DESIGN WA
STAGE ONE
DRAFT APARTMENT
DESIGN POLICY
TESTING REPORT

This design testing process was based on the advertised draft Apartment Design Policy of October 2016. The design and economic findings of this report should be understood to relate to the draft policy, and certain policy settings have changed in the final gazetted policy.

Site L1

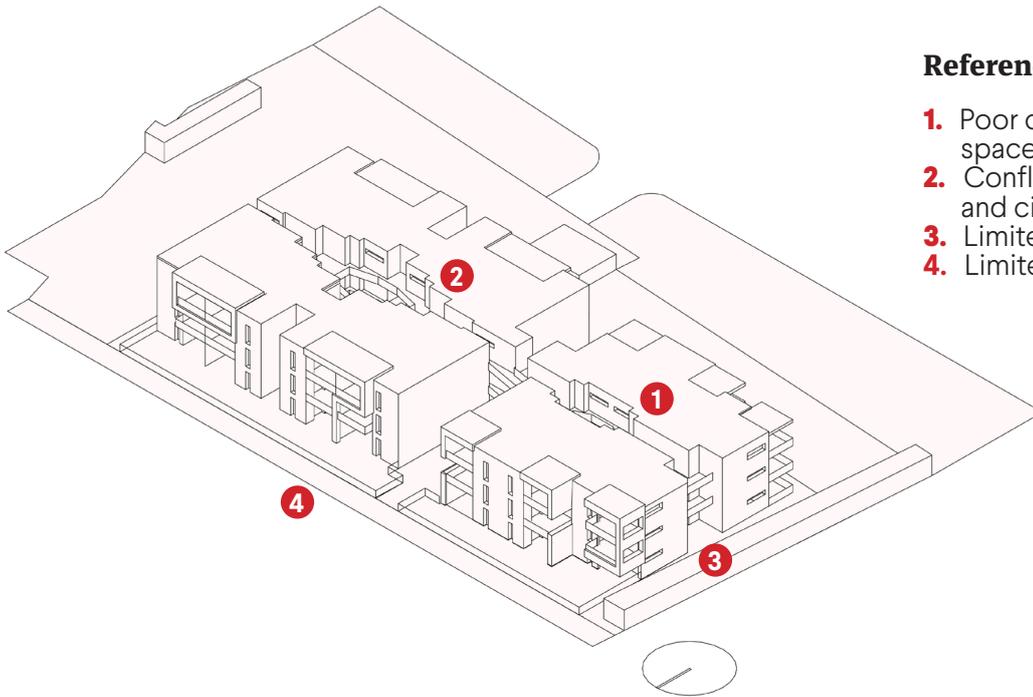
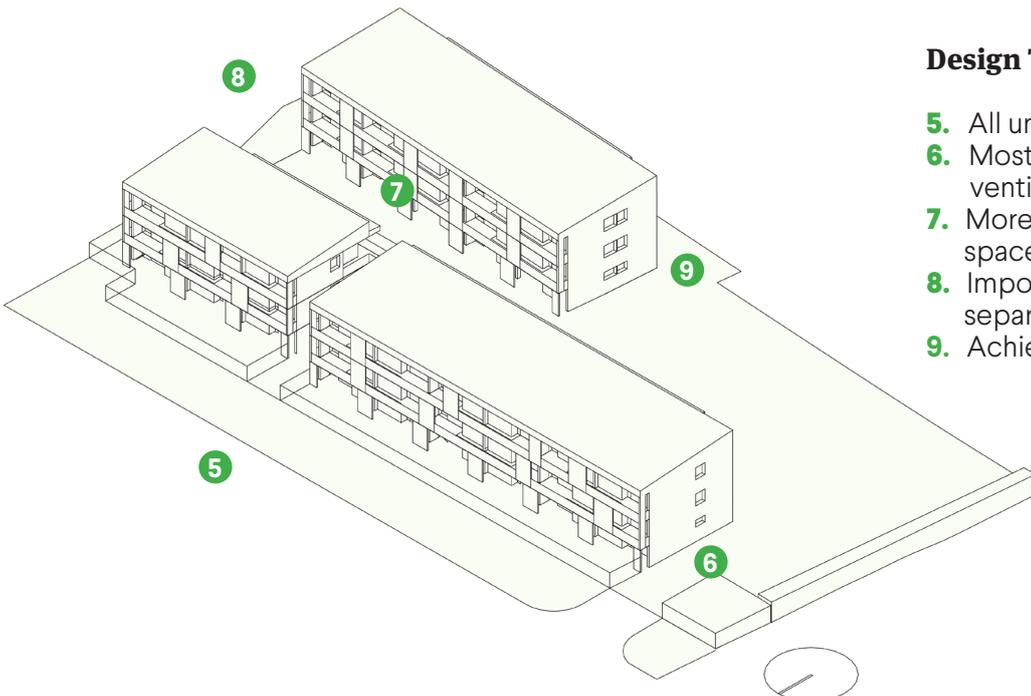
1. Poor communal open space
2. Conflict between bedrooms and circulation
3. Limited cross-ventilation
4. Limited Northern aspect (50%)

5. All units have Northern aspect
6. Most achieve cross-ventilation
7. More useable communal open space
8. Improved setbacks, building separation
9. Achieves deep soil criteria

Site L2

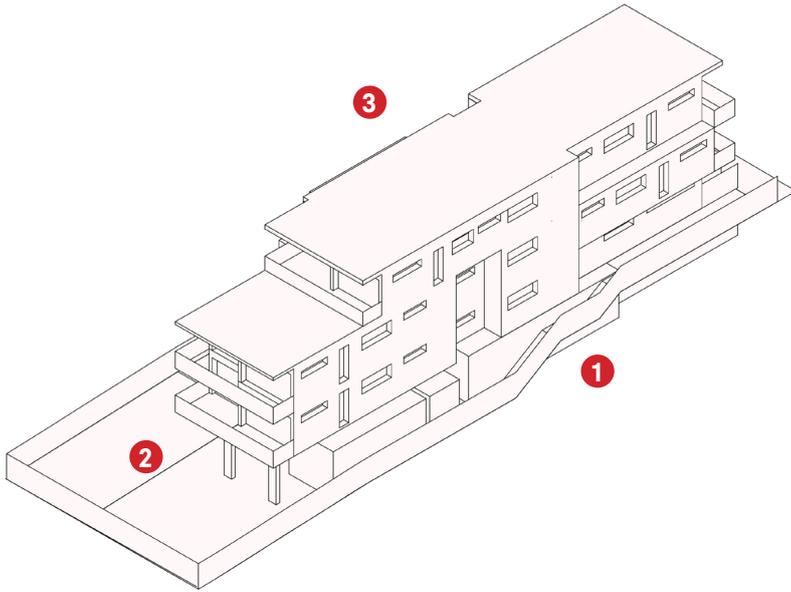
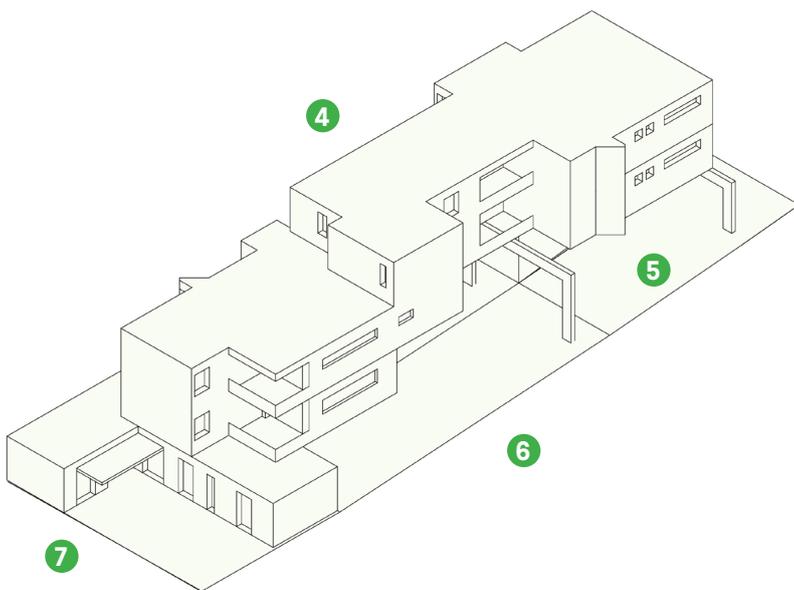
1. Limited side setbacks
2. Some balcony screening
3. Limited Northern aspect

4. Optimises Northern Aspect
5. Meets setback and visual privacy standards
6. Achieves deep soil + open space
7. Greater housing diversity

Site L3

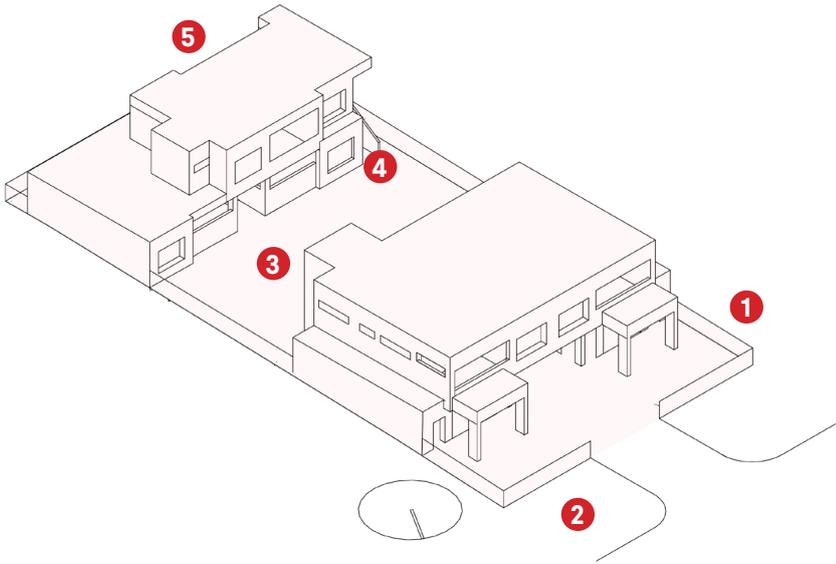
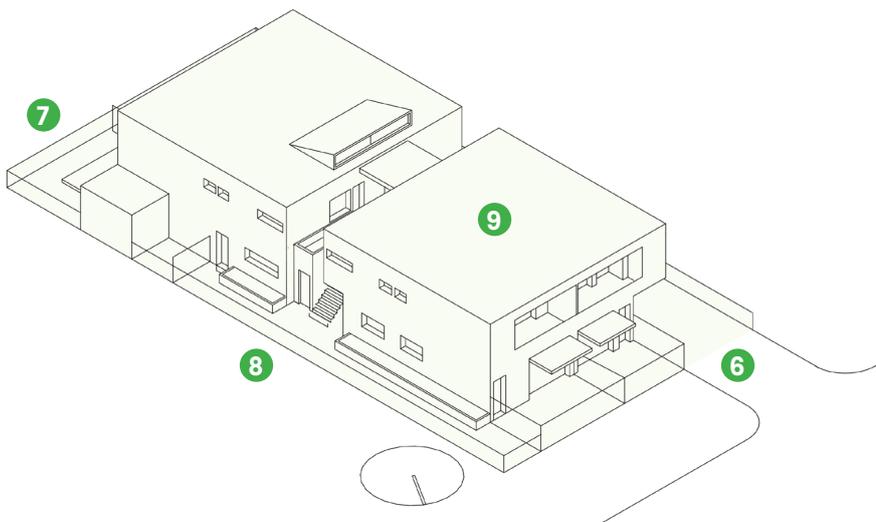
1. High site coverage with limited setbacks
2. No deep soil or landscaping
3. Layout dominated by driveway and parking
4. Conflict between bedrooms and circulation
5. Screening for visual privacy

6. Meets SPP7.3 setbacks and visual privacy
7. Achieves deep soil criteria
8. Separate pedestrian and vehicle access
9. Some room size criteria not met

Site M1

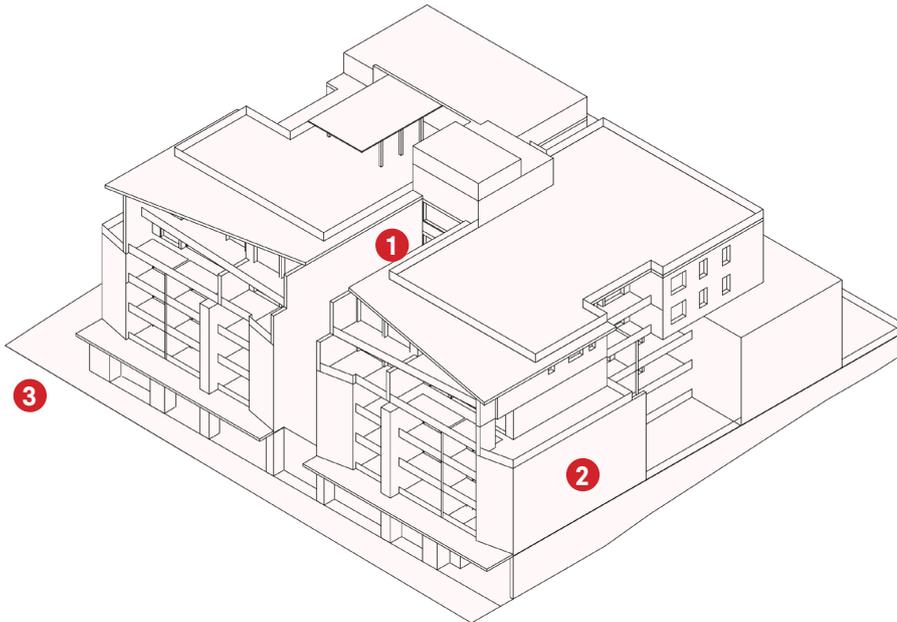
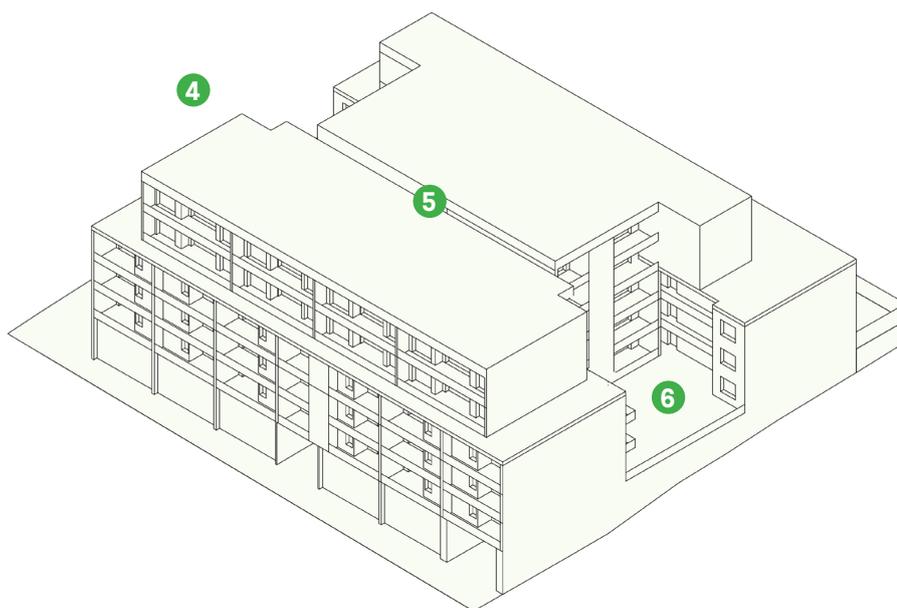
1. Internal corridors with limited day light
2. Limited cross-ventilation
3. No deep soil zones

4. Improves Northern aspect and cross-ventilation
5. Improved circulation space
6. Has deep soil areas and useable open space

Site M2

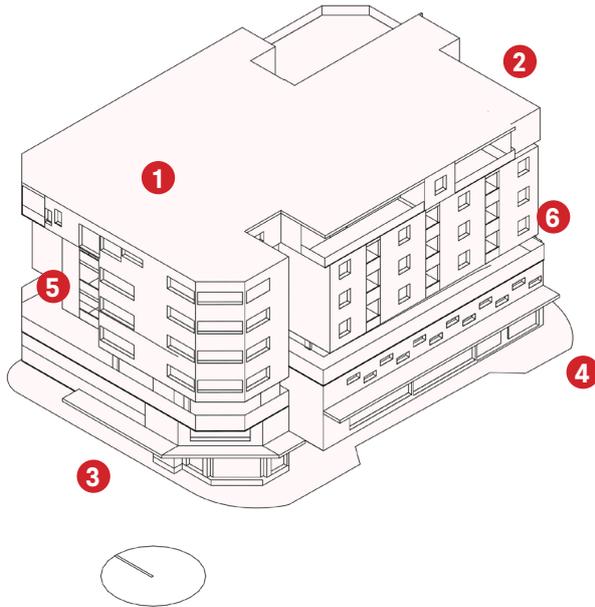
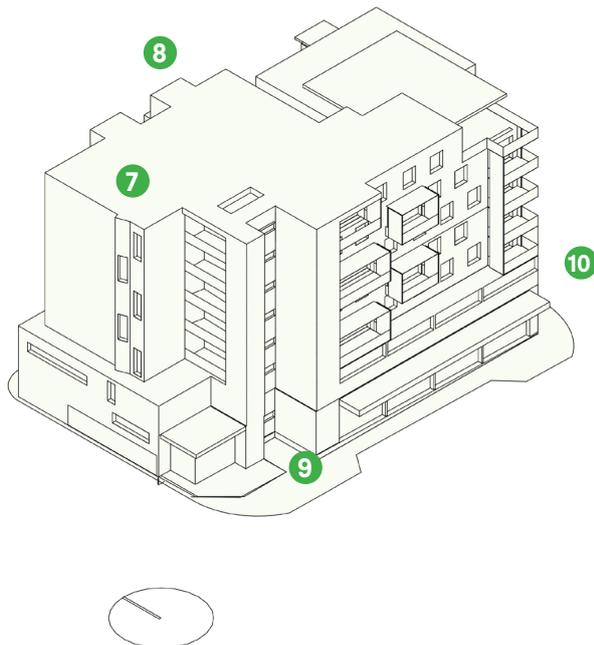
1. Windowless bedrooms, limited light and air
2. Poor cross-ventilation
3. Poor public domain interface
4. Limited landscaping
5. Air conditioning units on balconies
6. Poor facade articulation

7. No windowless bedrooms
8. Optimised Northern aspect and cross-ventilation
9. Improved circulation spaces
10. Deep soil areas and useable open space

Site H1

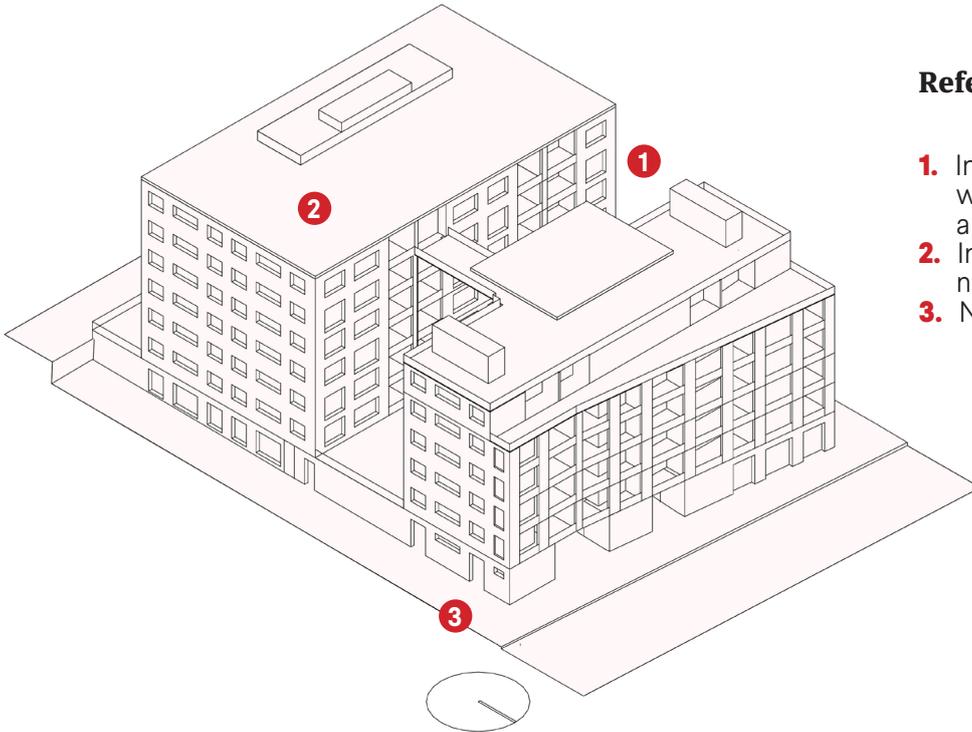
1. Inadequate building separation with poor outlook from apartments
2. Internalised corridors with no natural light
3. No deep soil areas

4. Improved building orientation with a better outlook for apartments
5. Improved circulation spaces
6. Combination of deep soil and planting on structure
7. More useable communal open space

Site H2

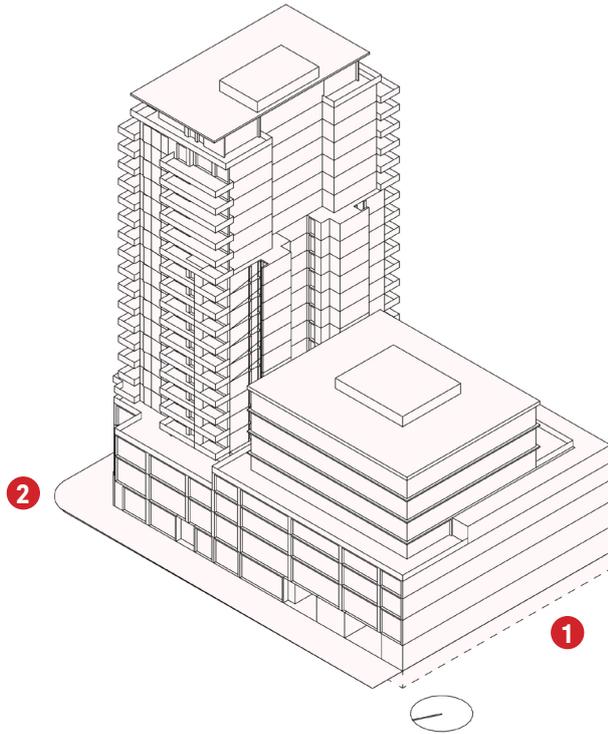
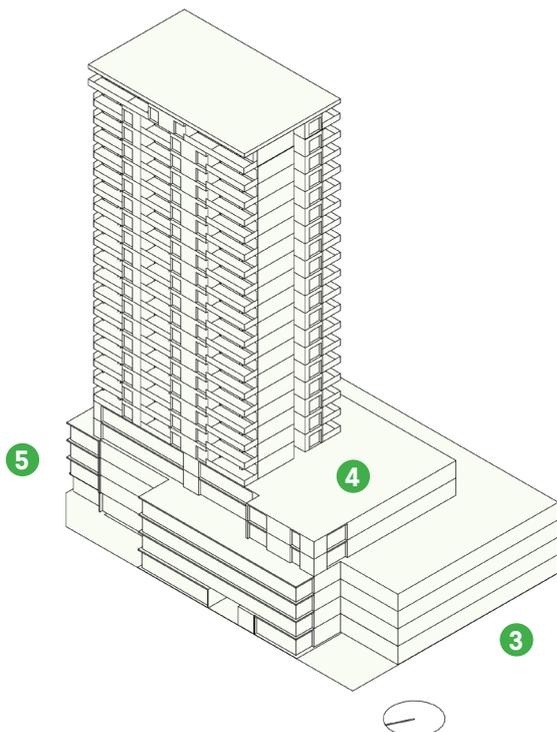
1. Internalised corridors with no natural light
2. No deep soil areas

3. Day lighting to corridors
4. Deep soil (8% of site) plus planting on structure (8% of site)
5. *Basement and podium carparking reconfigured
